Appendix L

Open House #1 Presentation Boards and Comment Response Forms

WARREN AVENUE BRIDGE MULTIMODAL PROJECT

Public Comments – April 24, 2023 Open House

ALTERNATIVE 2

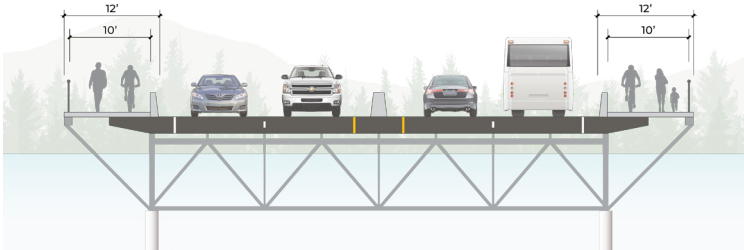
Alt 2 seems to be most practical, avoids purchasing \$1mil truck for WSDOT, and gives "good" width on both sides.

ALTERNATIVE 7

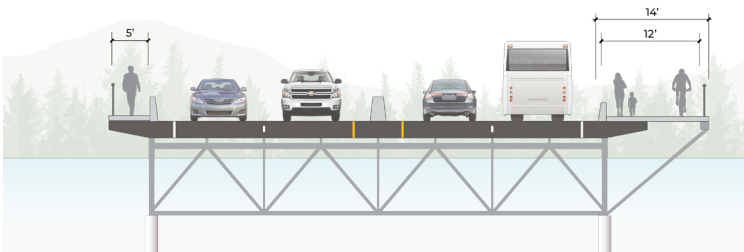
Alternative 7!! Must complete connectivity projects at same time.

ALTERNATIVE 3

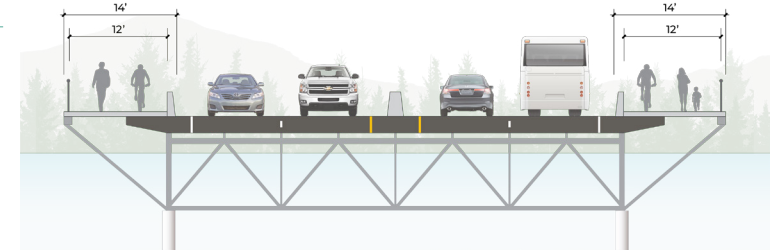
I prefer Alternative 3, 12 feet of space is needed to allow bikes and pedestrians to use both sides of the bridge comfortably.

ALTERNATIVE 7a

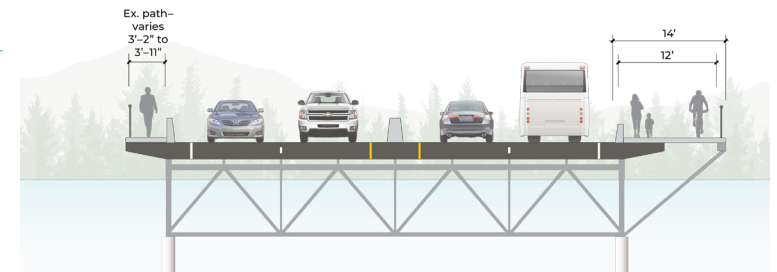
Option 7a seems to make the most sense. Wider–safer bike/ped lane and saves money as well.

POTENTIAL NON-MOTORIZED CONNECTION (TUNNEL)

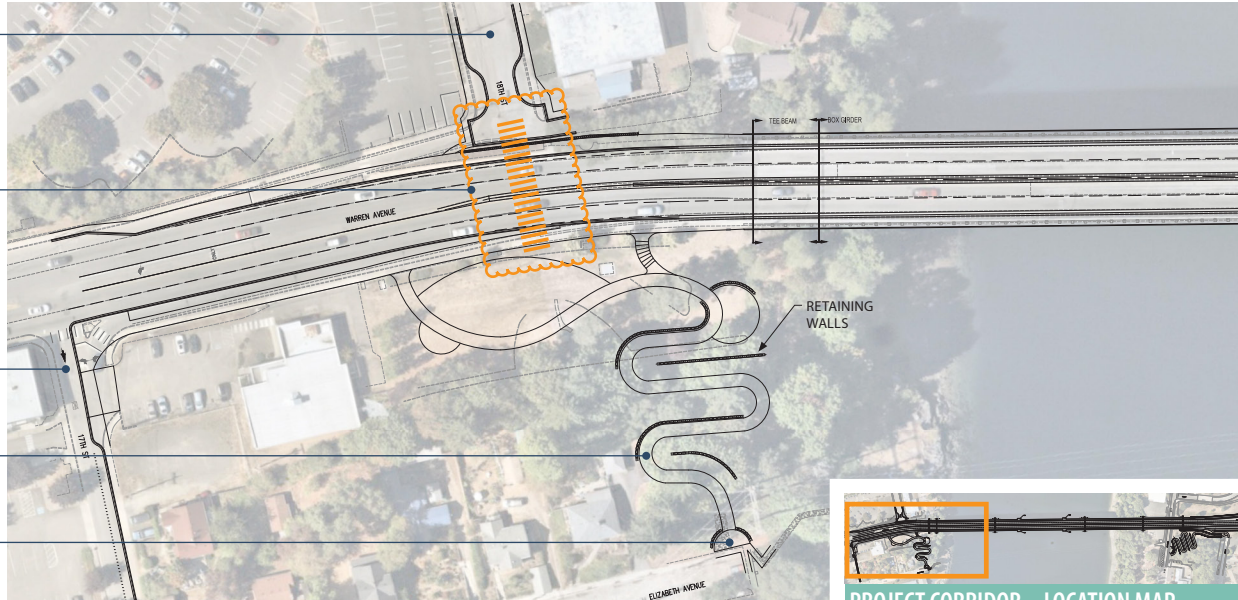
I like the idea of the tunnel on the south side. It will allow better access for people at Olympic College. I'm not a fan of the switchbacks on the north side, I'd prefer a longer gentle path along Juniper St.

JUNIPER STREET CONNECTION

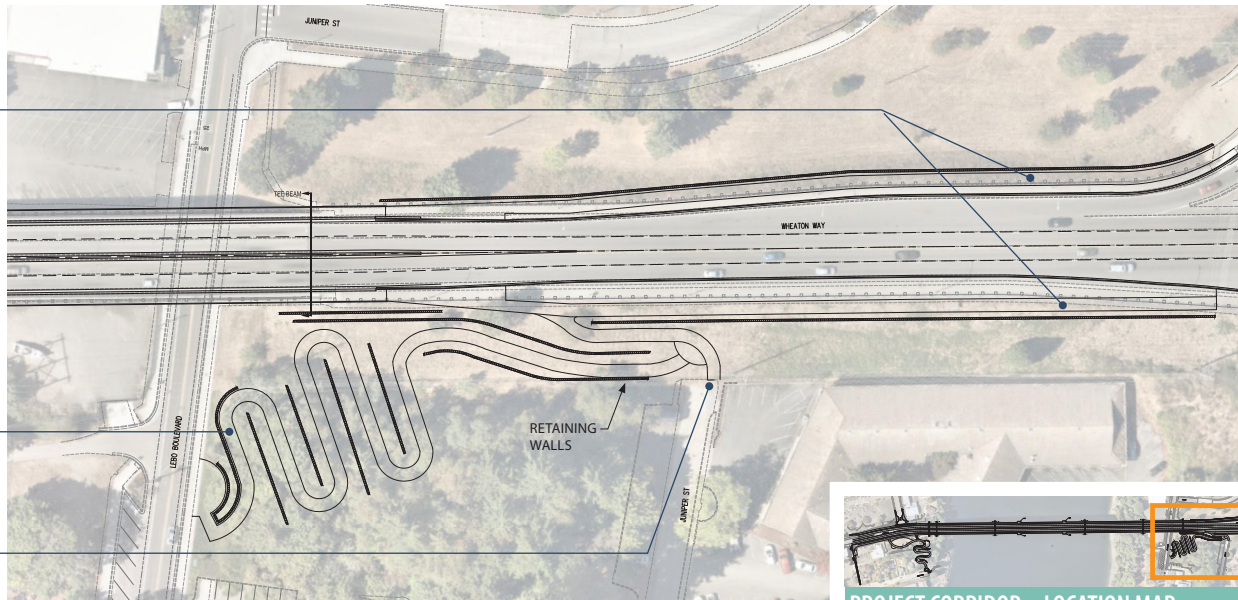
Juniper would be a great place for a bike/ped eastside exit from the bridge.

Please do not swale the bike path (the north off bridge concept) through the madronas at Sheridan Park. Instead use some of Juniper Street to make a longer curved path down through the park.
